PRODUCTION INSTRUCTIONS

REMOTE CONTROL PCBA

Date: 10-7-2020
Revision: 1.0
Author: Tony Little
Product: Electric Skateboard
Company: Globe Brand

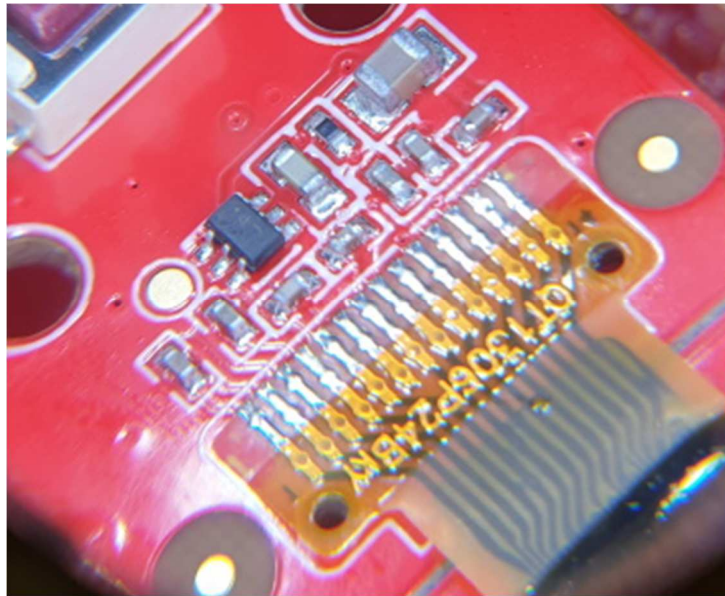
Please ensure the wireless module wire antenna from GNiceRF is included in BOM procurement. It was previously not included.

4.2 PCB PANEL DESIGN

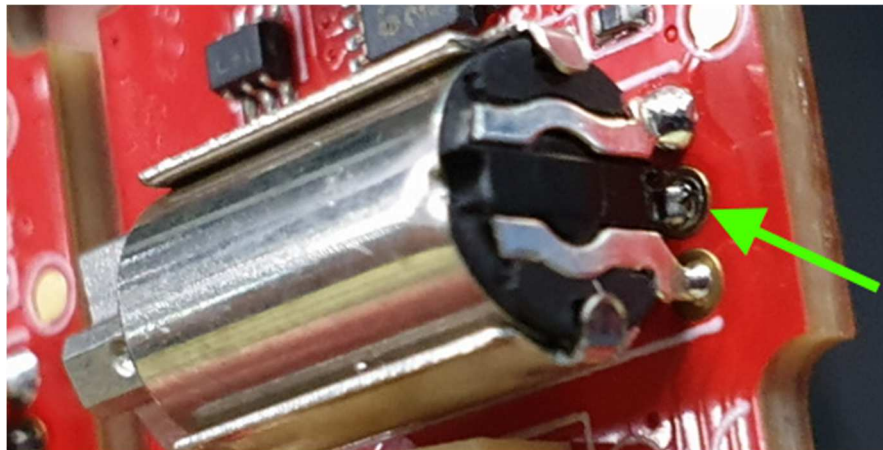
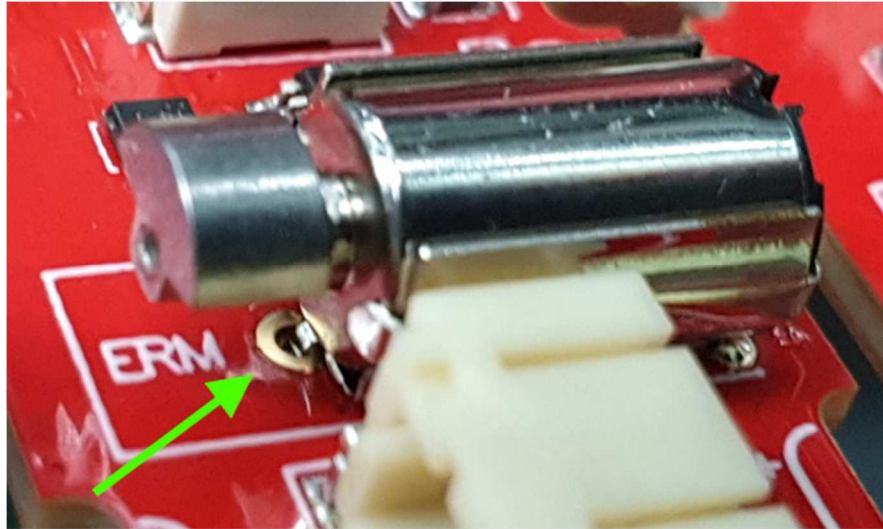
OLED damage had occurred from panel handling. The current panel used in production has 5mm breakoffs. The breakoff width needs to be increased to support and protect the OLED for handling and shipment. This tab must be 15mm.

5.1 ERM SOLDERING

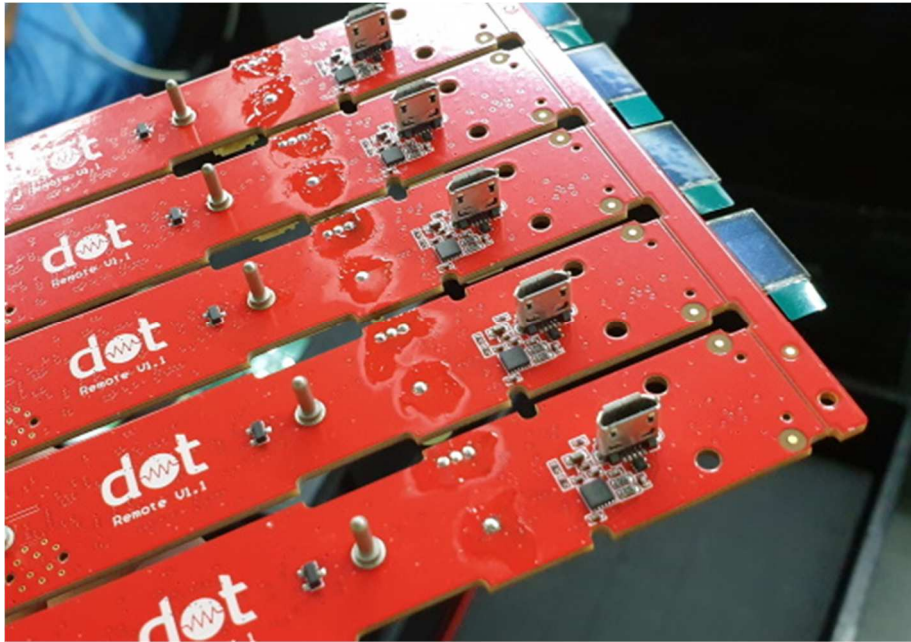
ERM soldering was a significant issue. The solder is not sufficiently wet in the through hole. This soldered joint needs to be improved.

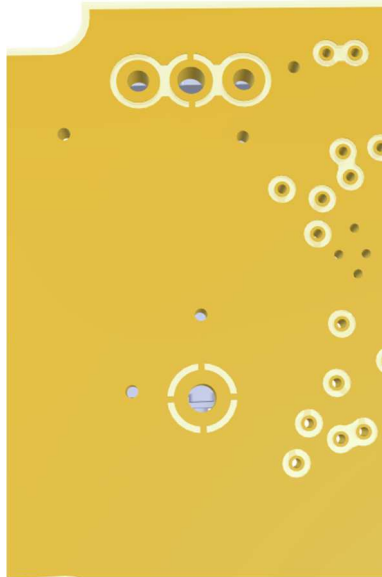
Union Circuits attempted to re-solder all these joints, however re-wetting the existing joint was not effective.

The copper pour on the PCB design is connected with thermal reliefs only on top and bottom layers. Internal layers have pad geometry for all 4 through holes, but no connection. Future PCB revision could remove pad geometry from internal layers only.

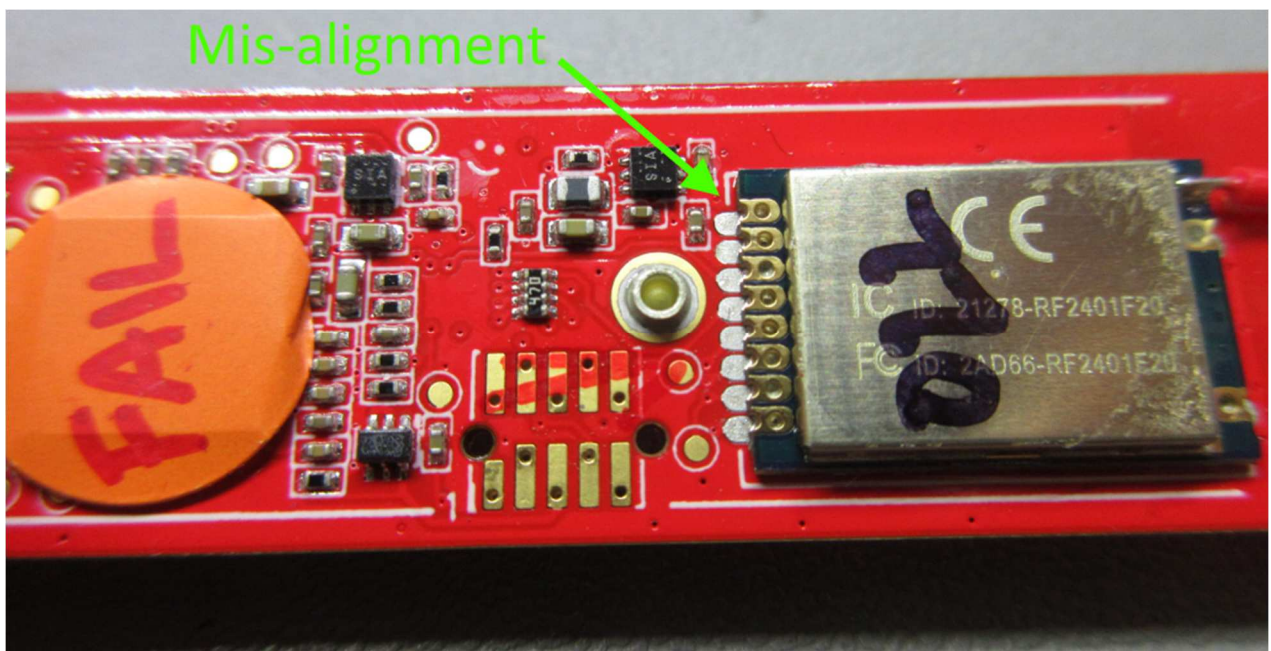
Recommend production first uses higher temperature to achieve better through hole filling. Do not rely on re-work to achieve solder fill.

6.2 TACTILE BUTTON ALIGNMENT

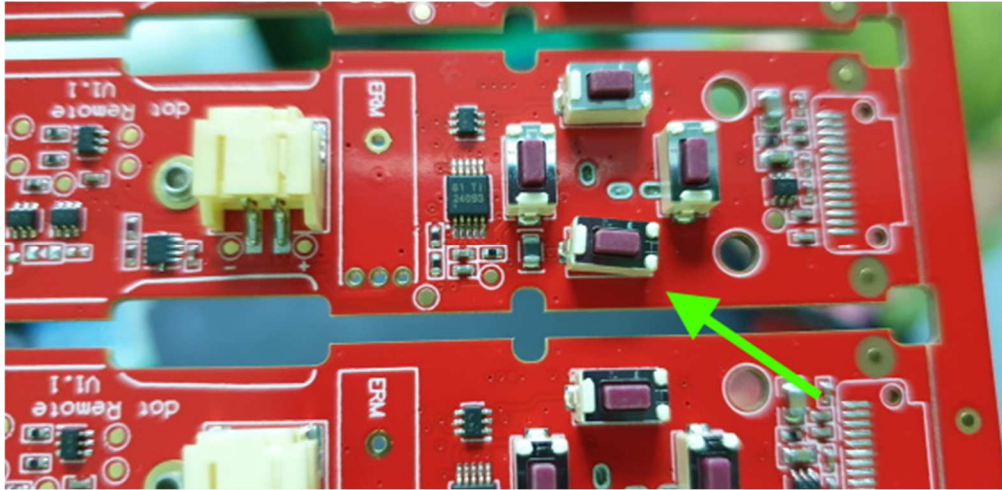
Rare issue. Tactile button misaligned.

6.3 USB SOCKET ALIGNMENT

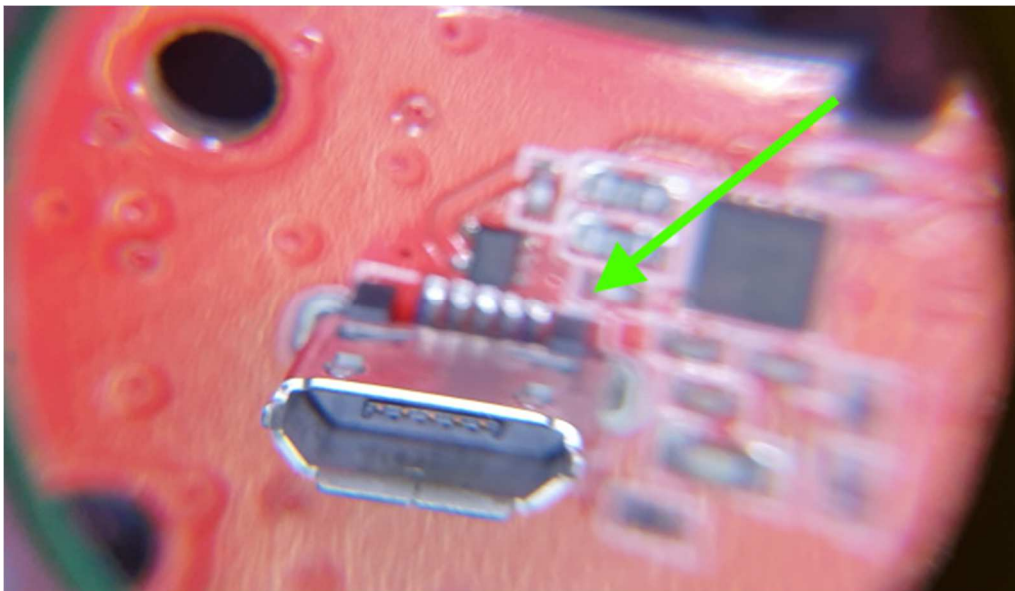
Placement error resulted in re-work for USB connector. Check placement prior to reflow.
